Office Action Summary	Application No. 10/802,337	Applicant(s) VALENTINI, MICHEL	
	Examiner Paul Devoti	Art Unit 3637

DETAILED ACTION

Sweers (US Patent Number 5555680) Figures 2 and 3

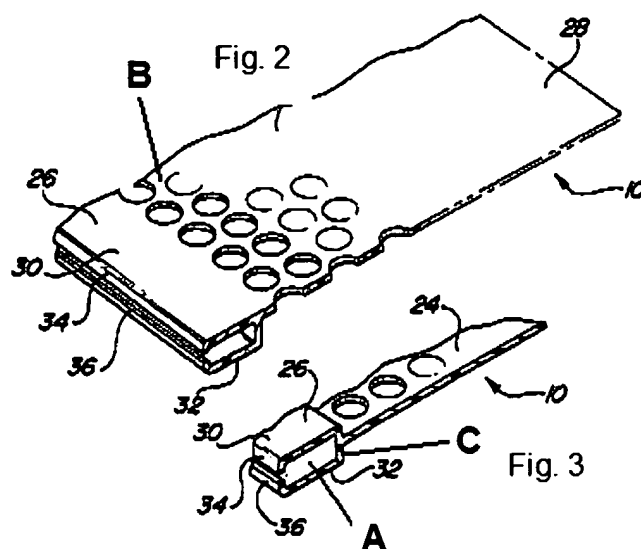
13. Sweers discloses in Figures 1 and 2 a gutter cover that has an elongated main section (24) with an outer side section (26). Additionally, he discloses perforations (B) in the main section (24). Sweers teaches that the outer side section has a channel (A) that opens away from the main section (24), which can fit over the lip (22) of a gutter. Sweers also discloses a gripping surface on the outer side section that extends upwardly, which is formed from the end wall (C) and top section (30) of the channel. The end wall (C) and upper edge (30) of the U-shaped channel inherently form a gripping surface, facing away from the channel opening, to pull the channel over the lip of a gutter. Regarding claim 8, Sweers discloses a channel defined by a top wall (30), bottom wall (32), and end wall (C) that join the top and bottom walls.

Hileman (US Patent Number 4592174) Figure 4

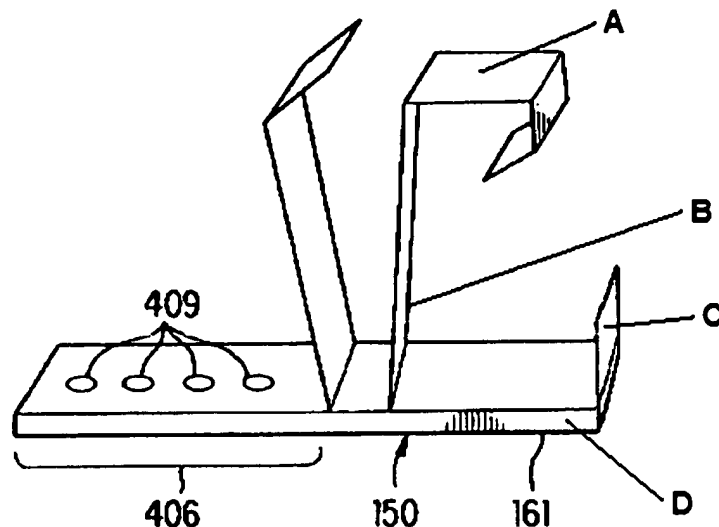
15. Claim 2 is rejected under 35 U.S.C. 103(a) as being unpatentable over Sweers in view of Hileman (US Patent Number 4592174). Sweers discloses the claimed invention, except for an inner side section with a defining slot that opens away from the main section that has a flexible flap mounted in the slot extending away from the main section. Hileman, however, teaches a slot (A) that opens away from the main section (21). This slot (A) holds a flexible flap (28) that extends away from the main section. Therefore, it would have been obvious to one having ordinary skill in the art at the time of invention to modify Sweers' gutter cover to include an inner side section with a defining slot that holds a flexible flap extending away from the main section, as taught by Hileman to provide a secure way to attach the gutter cover to another member.
